Reply to RC2 for the manuscript “A global satellite environmental data record derived from AMSR-E and AMSR2 microwave earth observations” by Du Jinyang, John S. Kimball, Lucas A. Jones, Youngwook Kim, Joseph Glassy, and Jennifer D. Watts.

Dear Anonymous Referee #2, thank you for your constructive comments on our manuscript. Please find below our responses to all the comments (in *bold and italic*). The changes on the manuscript were highlighted in blue.

Figure 1: The LPDR algorithm retrieval process.

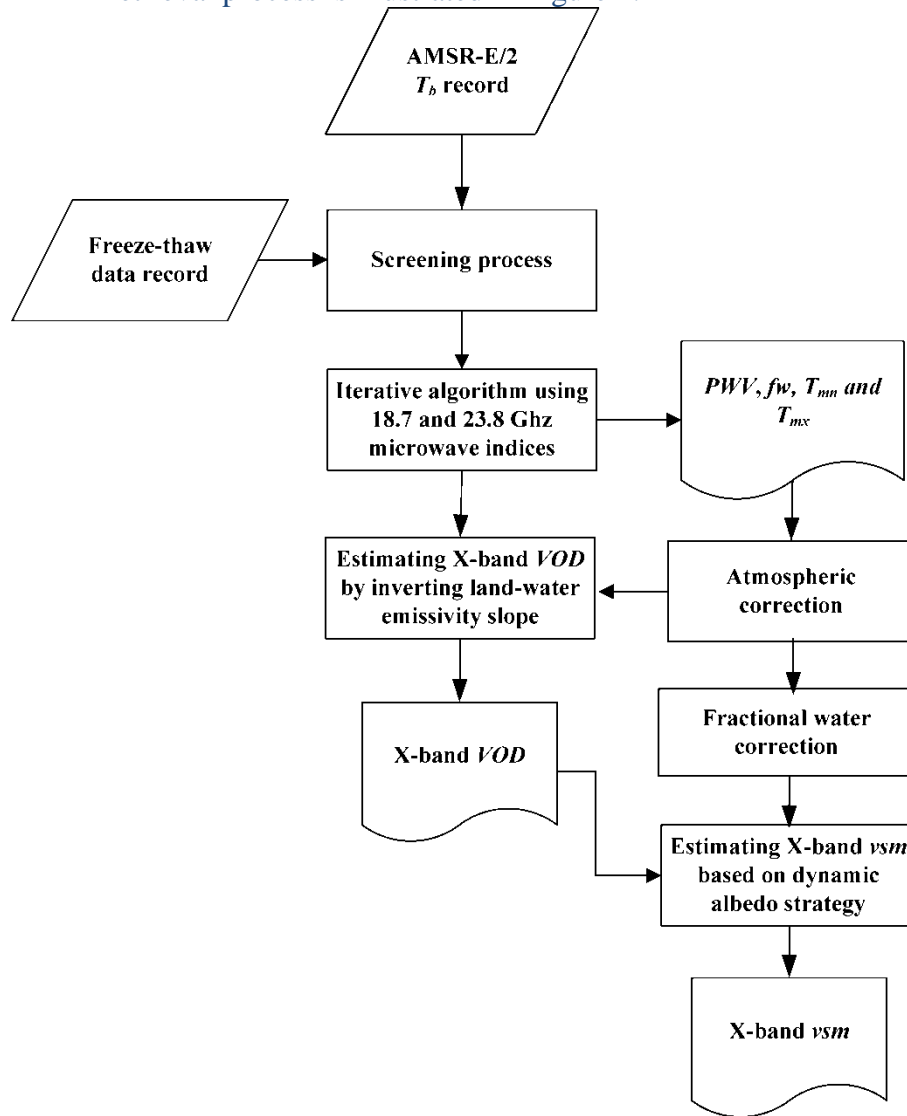
2. The word “internal consistency”, which is one of the most important motivations of this work, appears many times throughout the manuscript. However, it is still unclear to me how is this “consistency” preserved or reflected in the dataset. To me, all retrievals from one single sensor does not guarantee “consistency” as they may be obtained by using distinct retrieval algorithms. I therefore expect the authors to reorganize sections 2.1-2.2 and to more explicitly explain how these five retrievals are “internally” connected. To this end, a diagram or flowchart showing the general retrieval process and their physical connections is highly desired.

Reply: We accepted the reviewer’s suggestion. Sections 2.1-2.2 were revised for a better description of the algorithm with an additional Figure (Figure 1 of the revised manuscript) plotted to illustrate the retrieval process.

The following sentence and Figure 1 were added to the end of Section 2.2:

“The general LPDR retrieval process is illustrated in Figure 1.”

Fig. 1 Relationships between AMSR-E ascending f_w retrievals and MOD44W results for relatively small (< 0.15) (left) and relatively large (≥ 0.15) (right) AMSR-E f_w conditions.

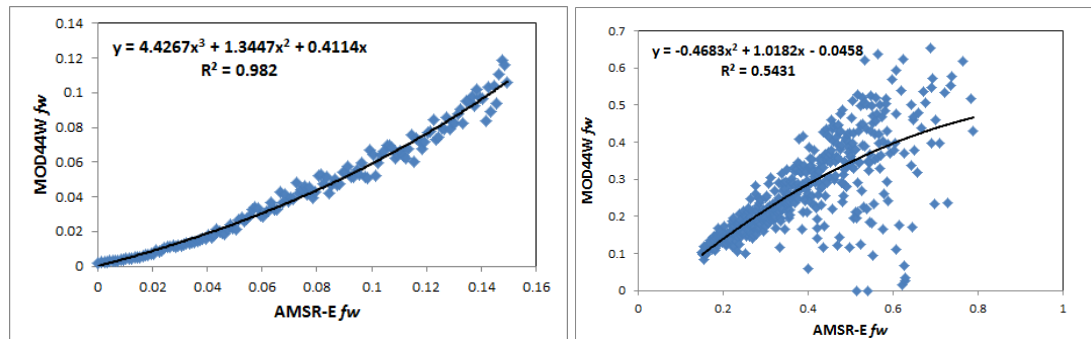
4. P5, L1-5: is the “empirical calibration” kind of CDF-matching AMSR-E/2 to the climatology of MODIS *fw*? Meanwhile, at P5, L5: how is the threshold of *fw*=0.15 determined?

Reply: As stated in the revised manuscript (Page 5; Line 11-14), the resulting AMSR-E *fw* values were first grouped into 1000 population ranges from 0.0 to 1.0 and 0.001 intervals; and the relationships between AMSR-E and MOD44W *fw* retrievals were analyzed based on the group mean values of AMSR-E *fw* data and corresponding MOD44W results. The method helps to establish a stable relationship between the AMSR-E and MOD44W *fw* results without being

affected by the data distributions. Alternative methods, including CDF-matching, may produce similar or better results for aligning the f_w data sets and will be examined in future work.

The relationships between AMSR-E and MODIS f_w data are different at relatively small and relatively large AMSR-E f_w conditions; the $f_w=0.15$ threshold was selected for describing the different relationships as illustrated in the figure below:

“... and (d) relationships between AMSR-E and MOD44W f_w retrievals were analyzed based on their mean group values and derived for two respective conditions representing relatively different relationship slopes: AMSR-E $f_w < 0.15$ and $f_w \geq 0.15$. The 0.15 f_w threshold was selected for describing the AMSR-E and MOD44W f_w relationships over the different AMSR-E f_w levels.”
